As a resident of the Timbercrest neighborhood, I have several concerns with the proposed Fox & Fogerty on Yosemite Drive proposed subdivision (Concept Plan 9-SC-24-C), that I hope the planning commission will address.

# Map 4: Soil Slippage Potential

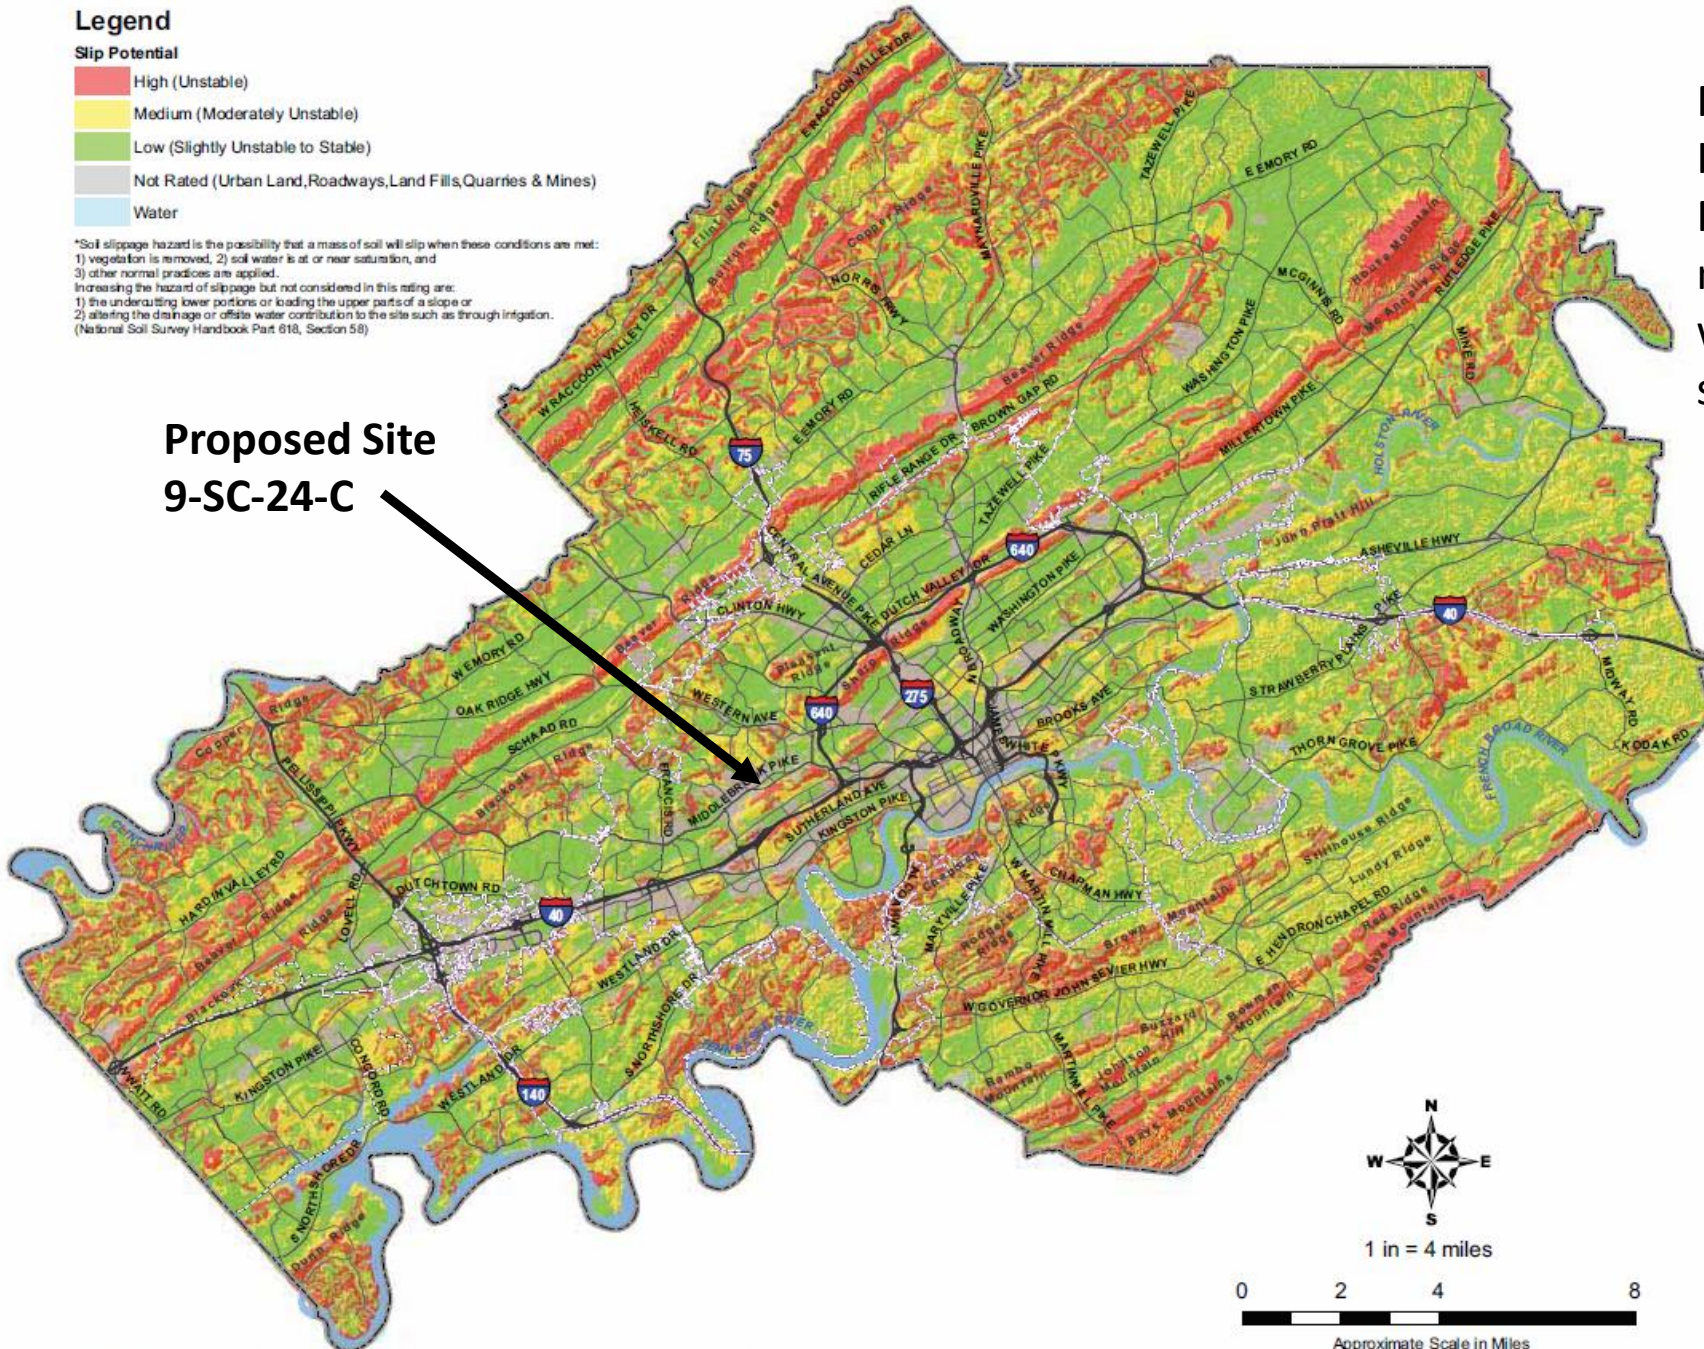
- The soils in the proposed project site are classified as soils with high slippage potential by the Knoxville-Knox County Hillside and Ridgetop Protection Plan and the Natural Resources Conservation Service (see attached figures). The proposed plan shows a new road and several lots to be constructed on the soils with high slippage potential. This portion of the project seems to be counter to the goals of Knoxville-Knox County Hillside and Ridgetop Protection Plan.

Map taken from the Knoxville - Knox County Hillside and Ridgetop Protection Plan. The map shows the proposed site within an area of high soil slippage potential.

Soil Slippage Potential—Knox County, Tennessee  
(Yosemite expansion)

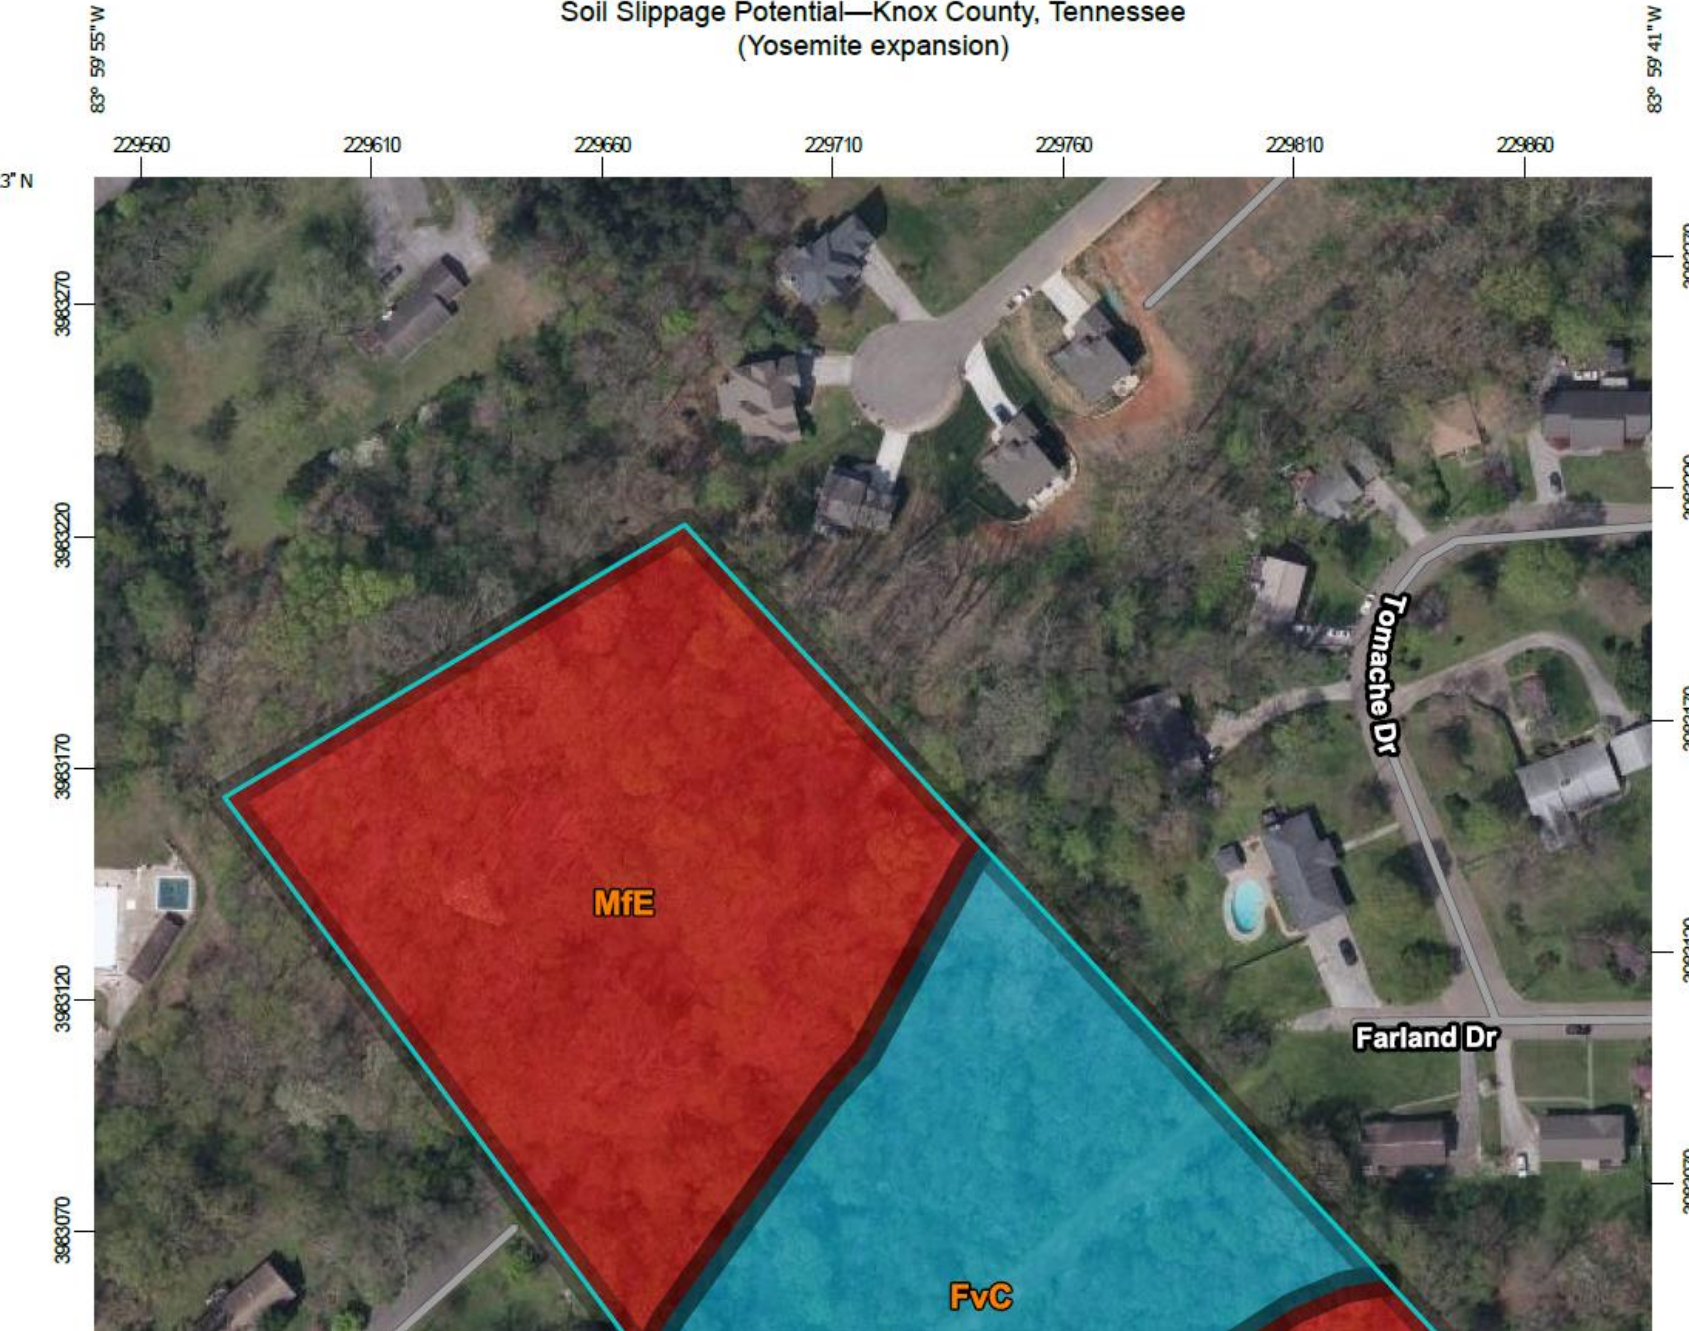
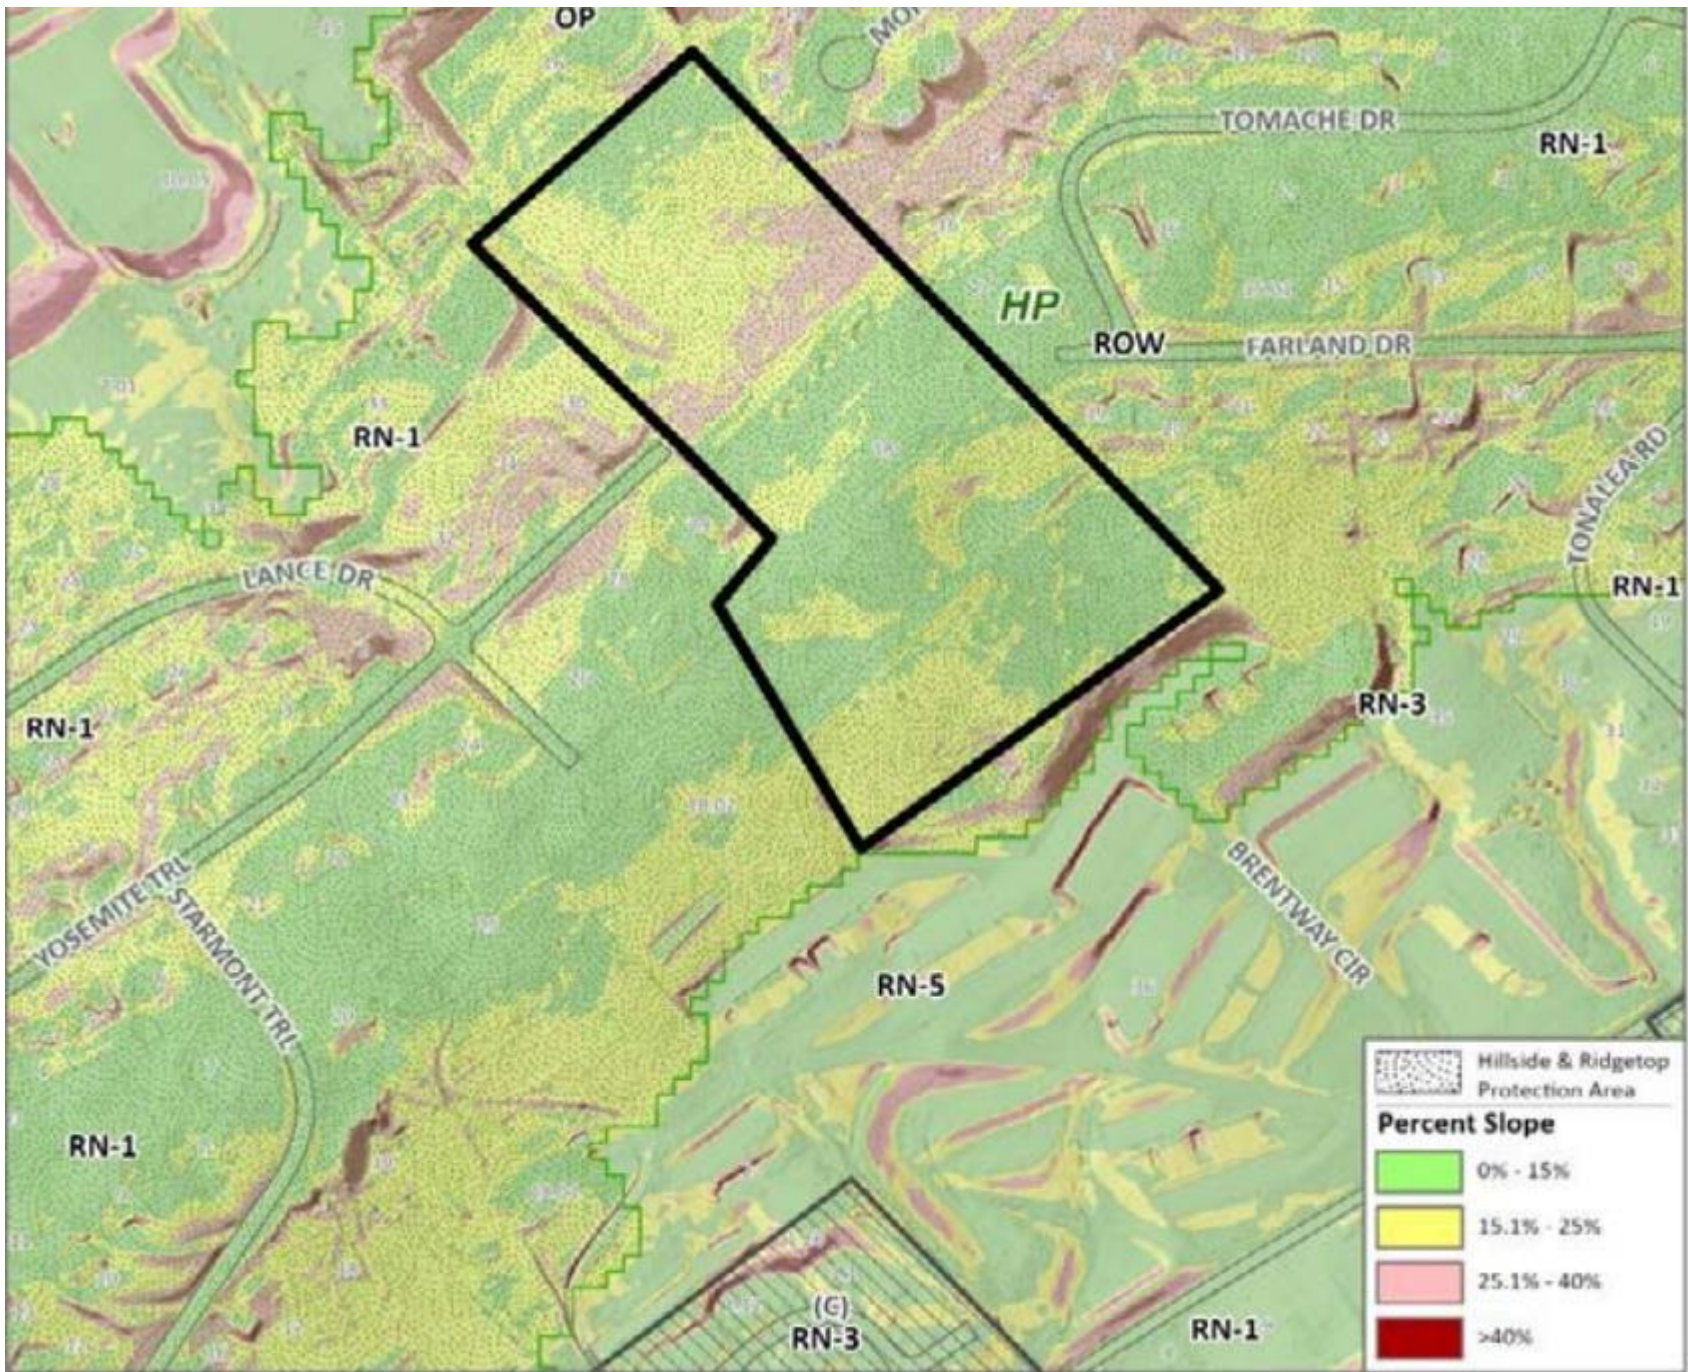
NRCS Soil Map showing Soil Slippage Potential at the proposed site. The soils in the northern portion of this site are at high risk of slippage. These same soils (MfE) are also deemed very limited for dwellings and road building by the NRCS soil survey.

Slope analysis from Subdivision Report for #9-SC-24-C. Note the area of 25-40% slope northeast of Yosemite Trail (pink shading). The proposed plan has a road connecting Yosemite Trail to Farland Drive with 5 lots north of the proposed road.

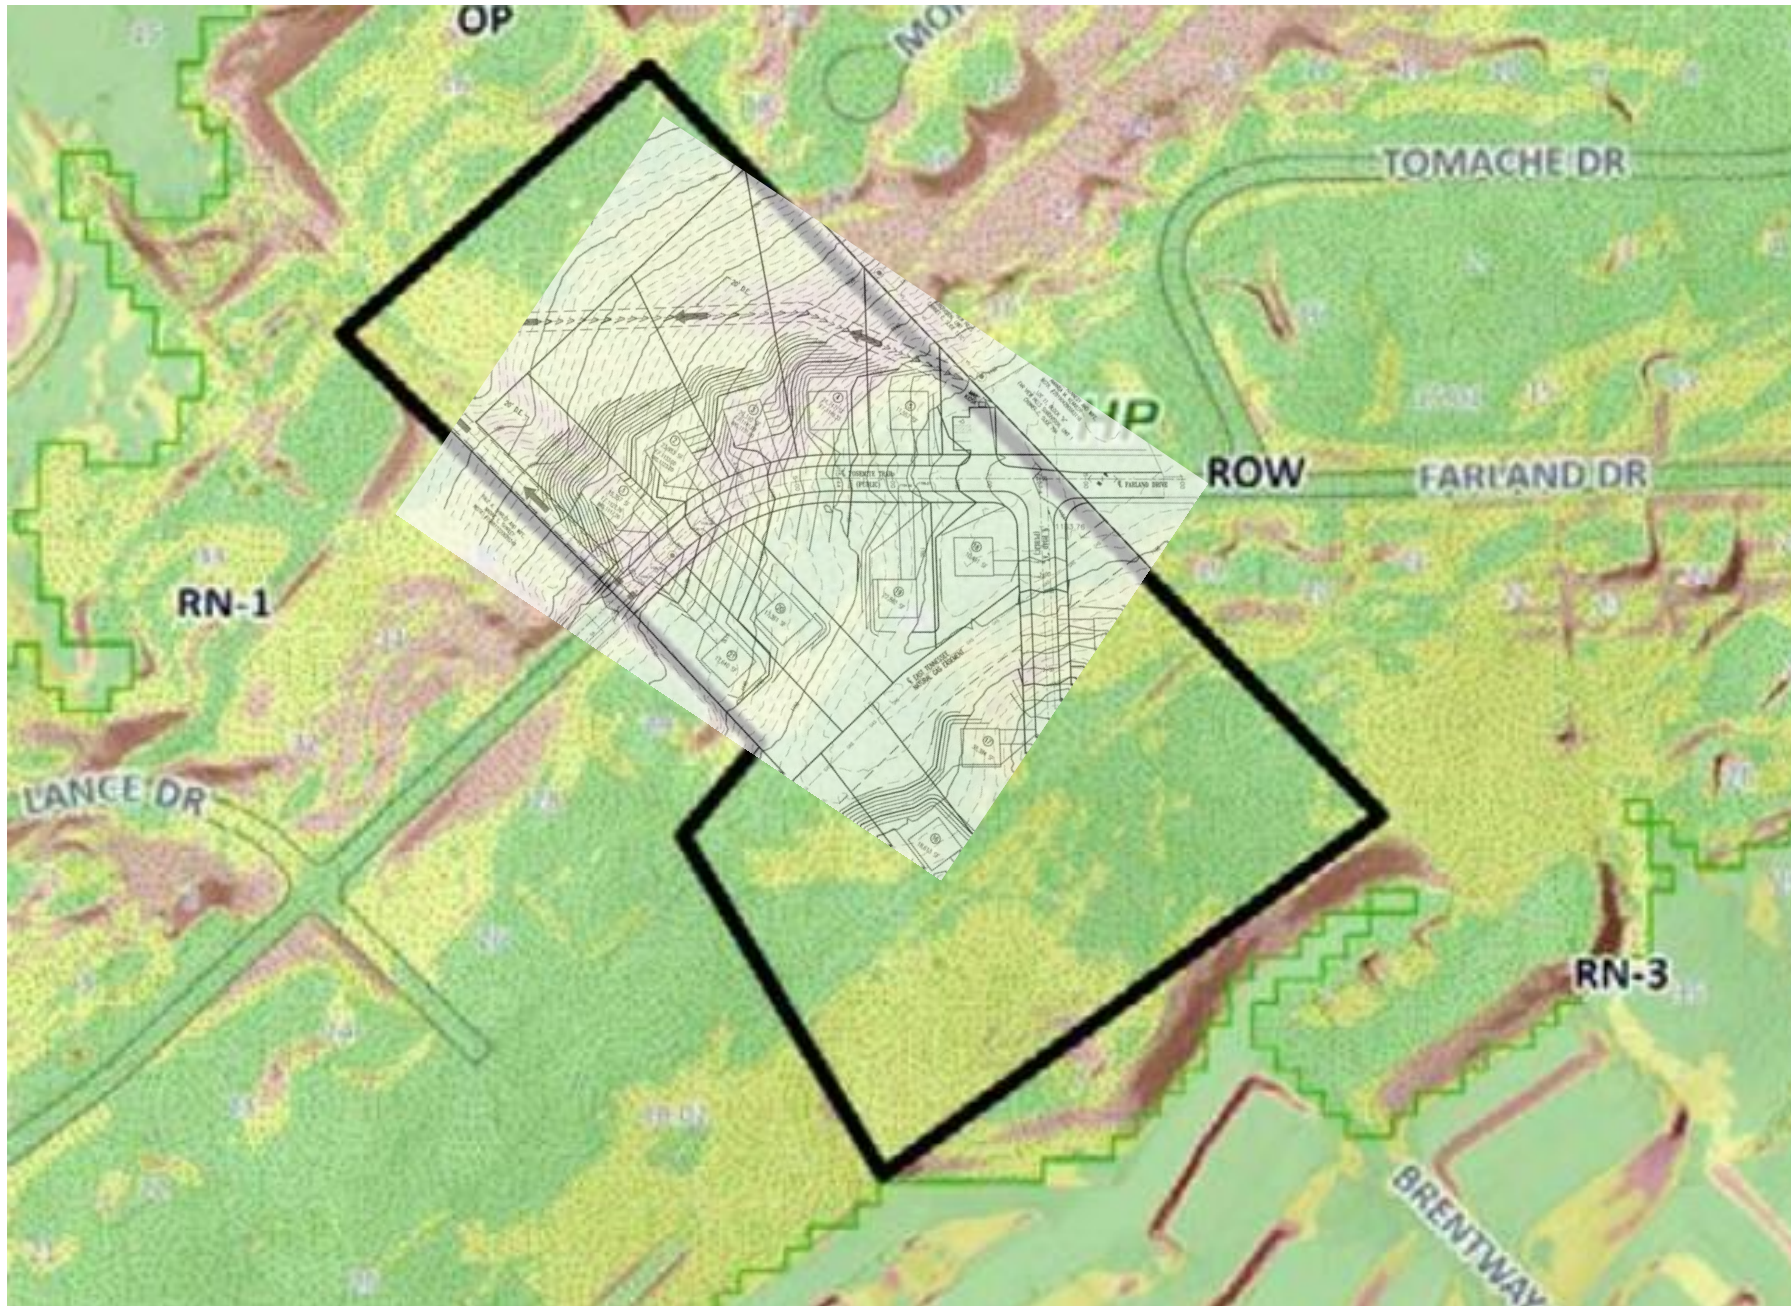
- The slope analysis for the proposed project shows areas northeast of Yosemite Trail with slopes greater than 25%. The submitted site plans show 3 lots and a road being constructed in the area with slopes greater than 25%. These lots appear to exceed the density limitations of the Hillside Protection Overlay Zoning District (Code of Ordinances City of Knoxville Tennessee, Appendix B, Article 8.9, Table 8-6).
